Office of
Environment
& Heritage

DOC16/242158

Gunlake Quarry extension project (SSD 7090)

Attachment one: Biodiversity comments on the Gunlake Quarry extension project EIS

APPENDIX 6
VEGETATION OFFSET PLAN

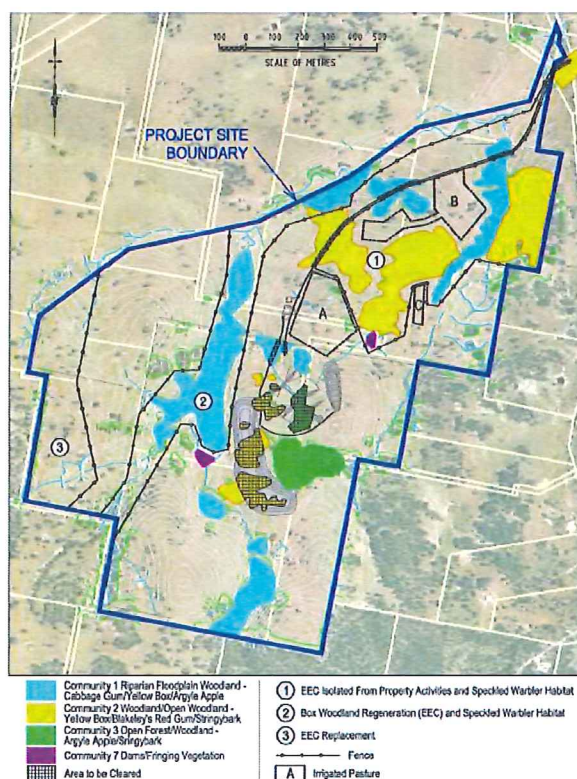
be additional to other legal requirements". The previously agreed offsets should be already in place and be managed to achieve compliance with previous consent conditions. In addition to this, the impact area for the proposed extension area impinges on previously identified offset areas that were previously committed to in the original approval 07-0074 (see image below from original approval). OEH has received an email from Ed O'Neil from Gunlake Quarry stating that they have modified where the offsets would be positioned on the block but it has not been shown how this would be compliant with previous consent conditions or their intent – or where the offset areas are.

- The management actions that are currently being undertaken in previously agreed offset areas
- The area and locations of the current offset proposal

all applying the same method and policies. Other quarries in the areas are not re-using previously assessed and secured offsets.

The above plan is amended by:

- deletion of irrigation area B in Offset Area 1; and
- additional fencing to be provided on the southern side of Chapman's Creek between Offset Area 2 and Offset Area 3.
